# TRAVILLE PARCELS I, J, AND K (8-03012)

**TRAVILLE**

**TRAVILLE SITE PLANS #8-03012  
CONFORMANCE TO THE DIAGRAMMATIC PLAN**

**SITE PLAN 8/13/12**

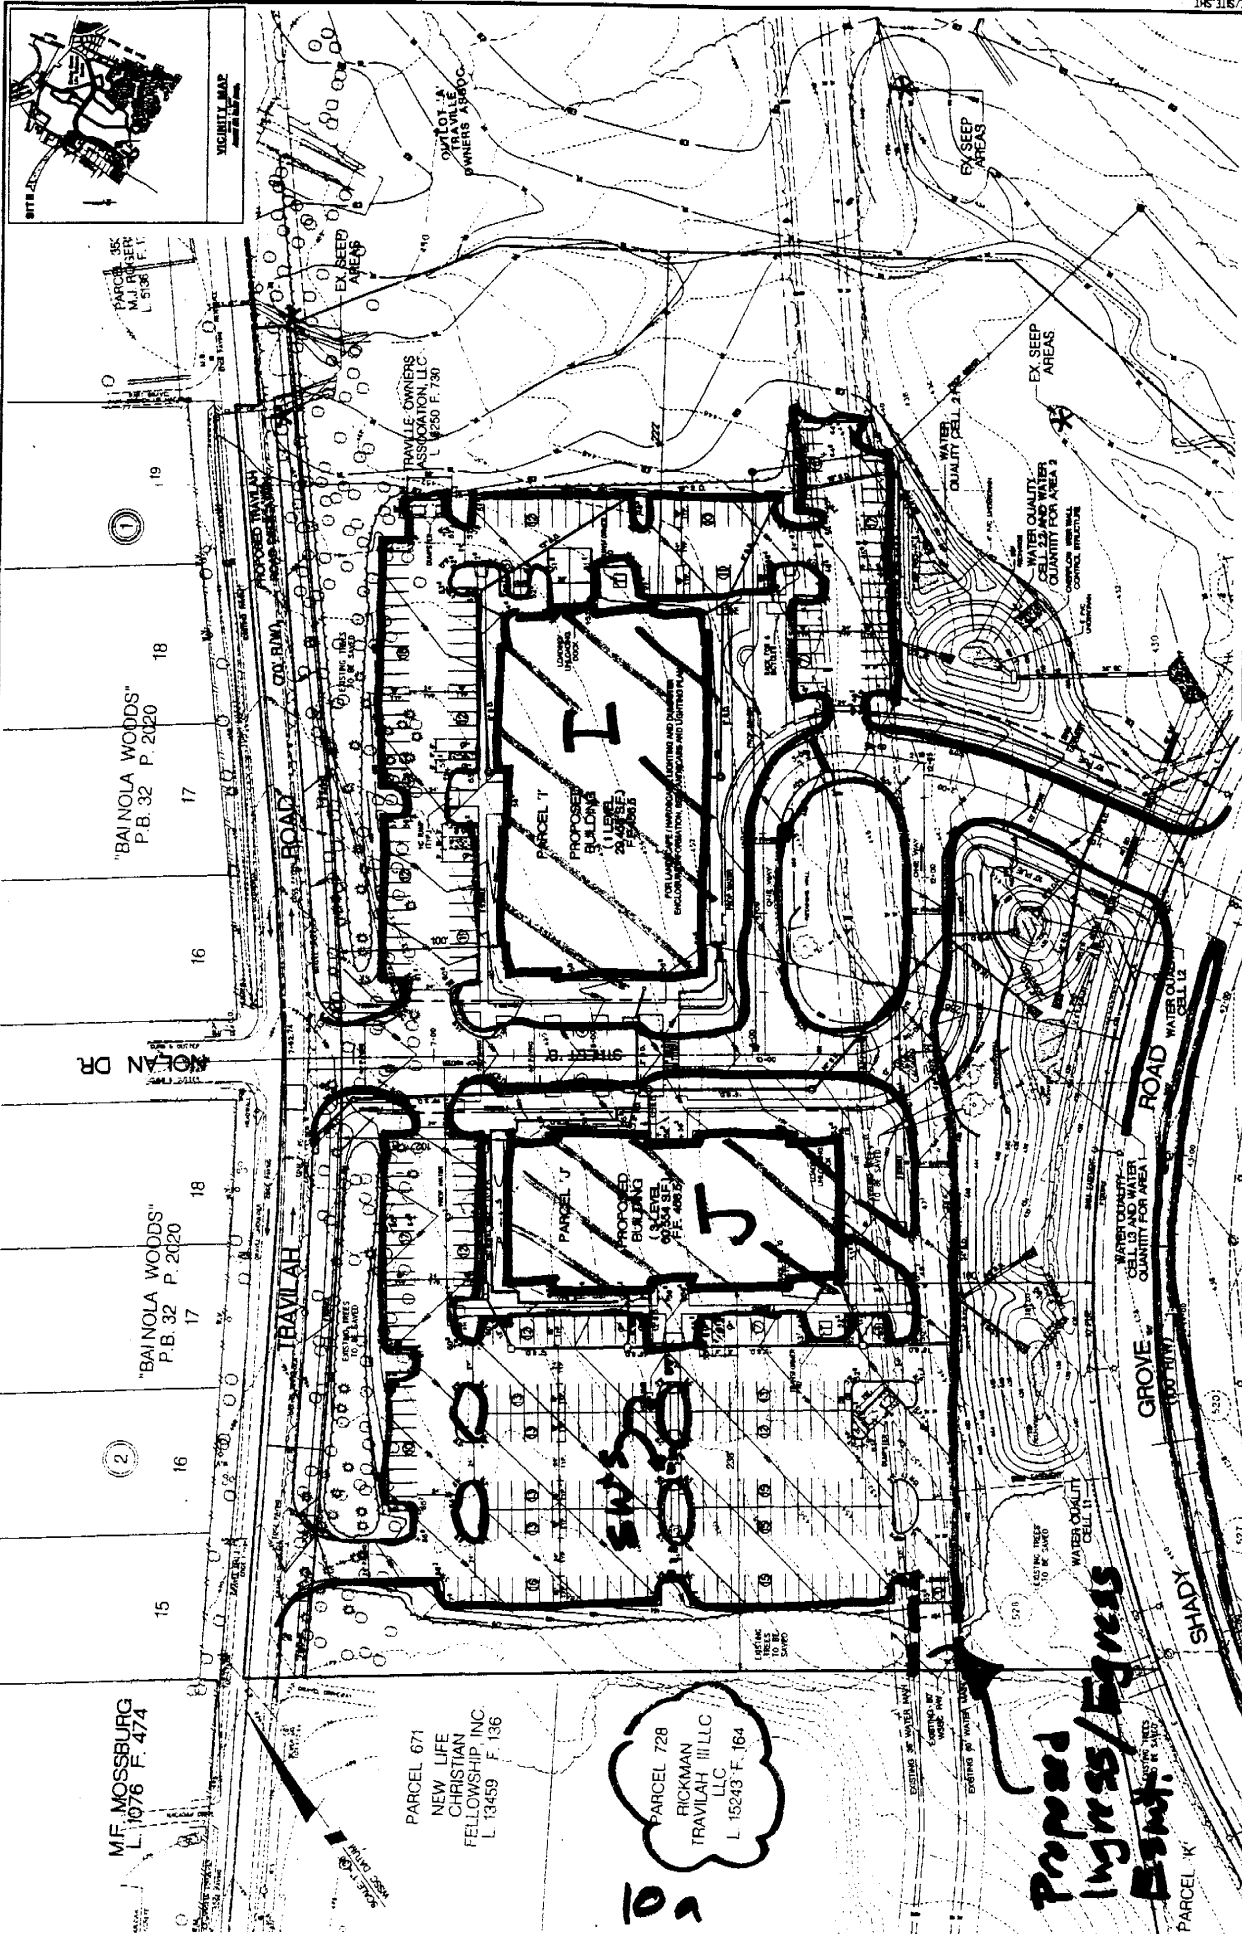
Landscaping for the site includes shade trees along the internal street, along Travillah Road and within the parking lot. Street trees are already proposed along Shade Grove Road via earlier site plan approvals. The central island to the street is planted with decorative flowering and shade trees and low growing shrubs. The parking lot is screened from adjacent properties by shade trees. The applicant needs to add an evergreen hedge adjacent the right of ways and shade trees next to adjacent properties.

Parking lot lighting is important because of the residential uses across Travillah Road and Shady Grove Road. The applicant needs to submit lighting plans that show the light fixture and type of light distribution characteristics to assure the lack of glare and no visibility of lamp (light bulb).

**OVERALL PEDESTRIAN CIRCULATION PLAN**

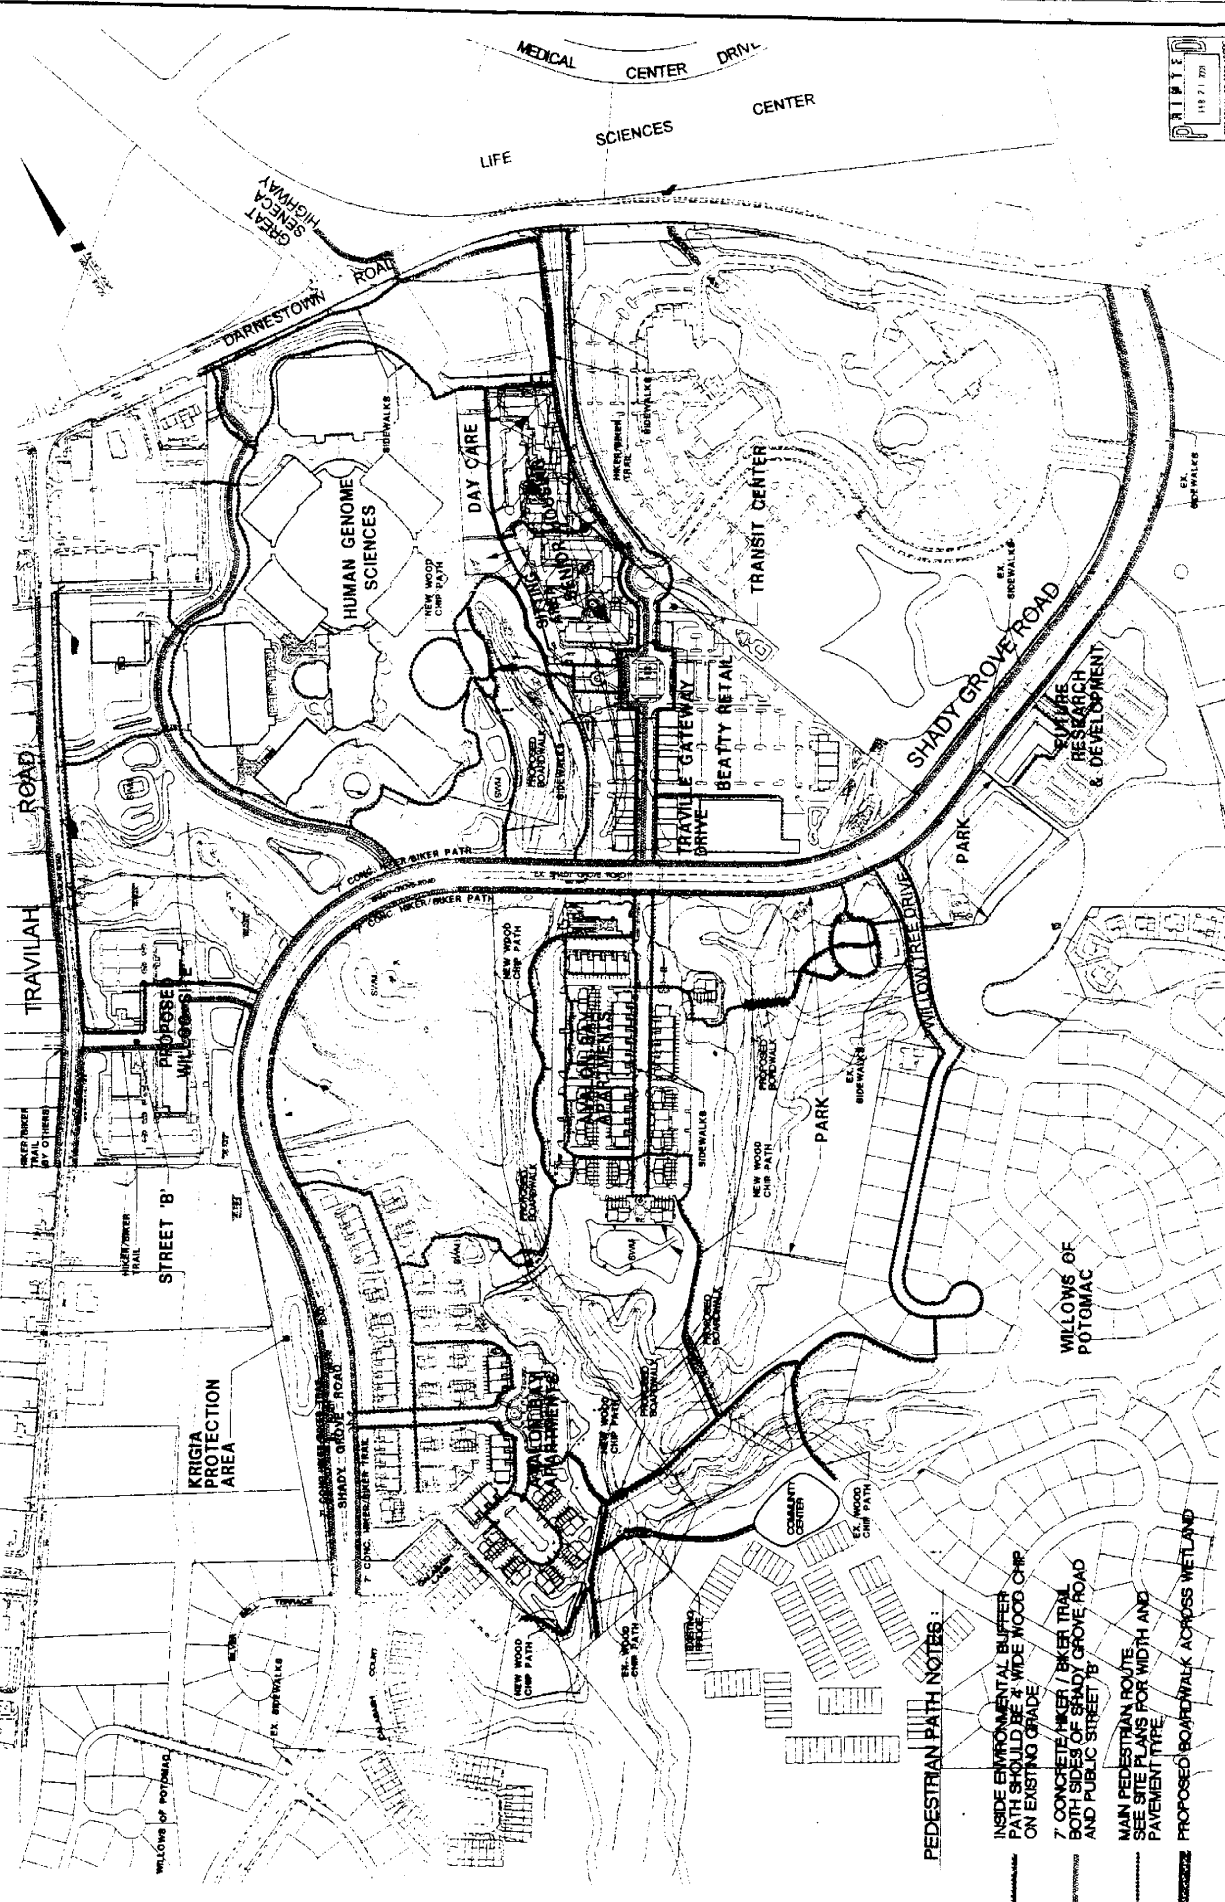
Pedestrian paths conform to the Diagrammatic Plan and link to off site connections seamlessly.
